Merin Road Community

Special Use Permit Planned Development

Response to Ms. Martha Mersereau's Concerns addressed to the Stormwater Advisory Board

Consideration of the simultaneous overtopping of retention ponds – Continued:

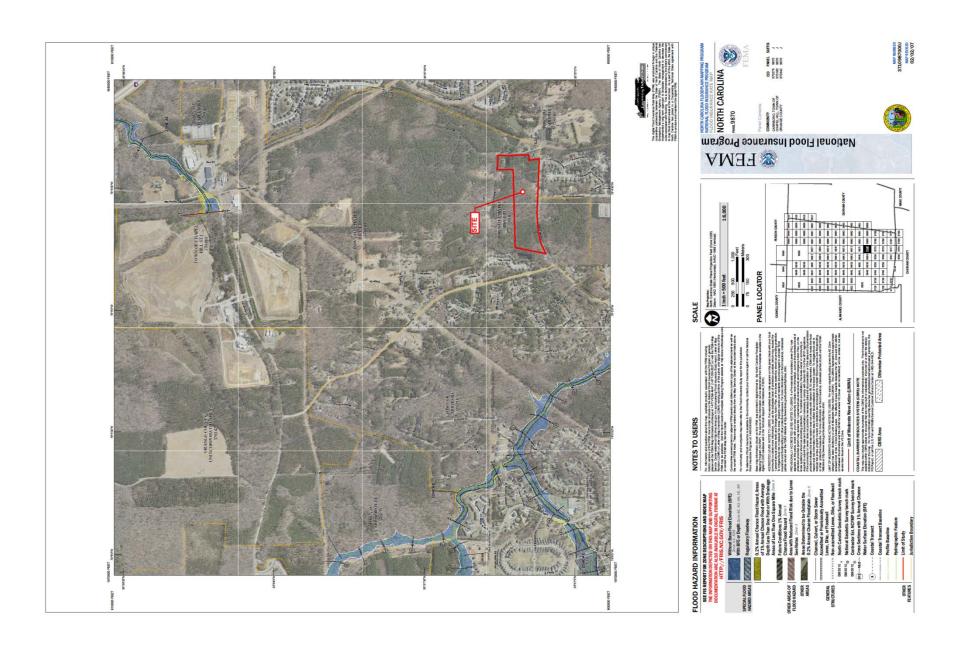
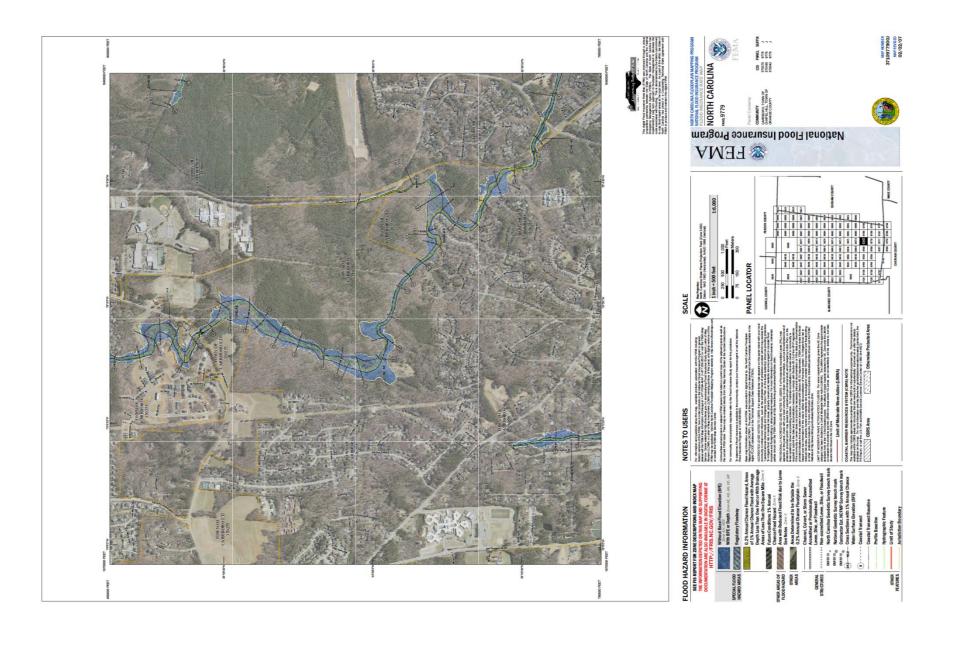
Statement #1: Ms. Mersereau states if the retention ponds from Burch Kove and Merin Road were overtopped at the same time, the potential flooding problem would be greatly exacerbated.

Response #1: Dams associated with the stormwater control measures are designed for the 100-year storm and must provide at least 1-foot of freeboard.
